**RHODE ISLAND TURNPIKE AND BRIDGE AUTHORITY  
JAMESTOWN, RHODE ISLAND**

**NEWPORT/PELL BRIDGE PIER 5W GIRDER TEMPORARY SHORING AND  
BEARING REMOVAL AND REPLACEMENT**

**ADDENDUM NO. 1**

RHODE ISLAND TURNPIKE AND BRIDGE AUTHORITY  
CONTRACT 22-04R  
NEWPORT/PELL BRIDGE PIER 5W GIRDER TEMPORARY SHORING AND BEARING REMOVAL  
AND REPLACEMENT  
RESPONSE TO QUESTIONS FROM PROSPECTIVE BIDDERS

# Pay Item BR1 – Bearing Removal and Replacement

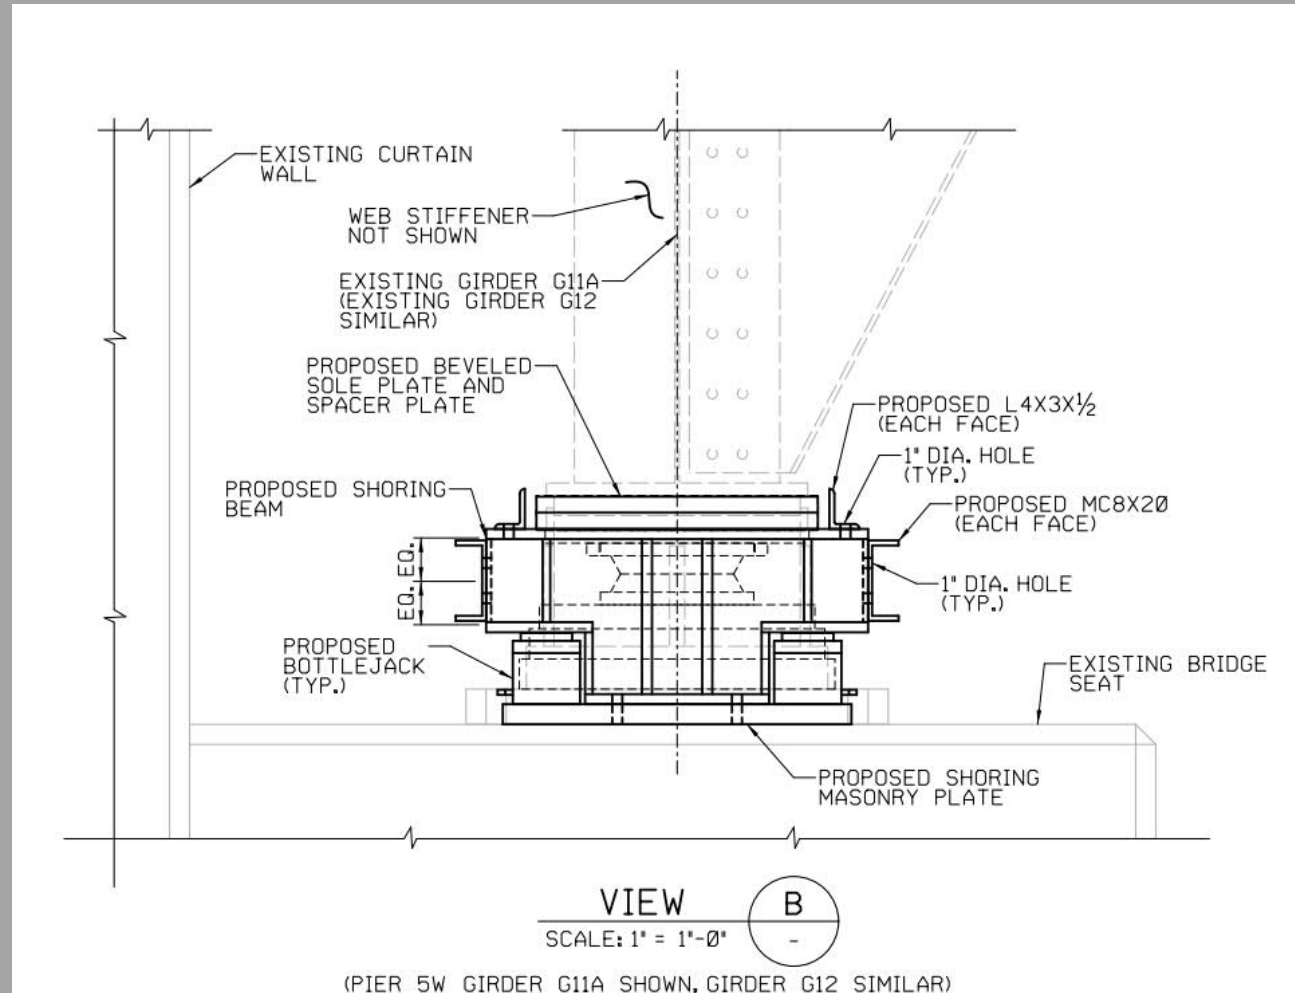
8. Please clarify which item the bearing replacement is paid under.

Response: The cost of procuring the new bearings is paid under Pay Item BR2. The cost of handling the new bearings after receipt, installing the new bearings and removal of the existing bearings and removal of the shoring systems are paid for under Pay Item BR1.
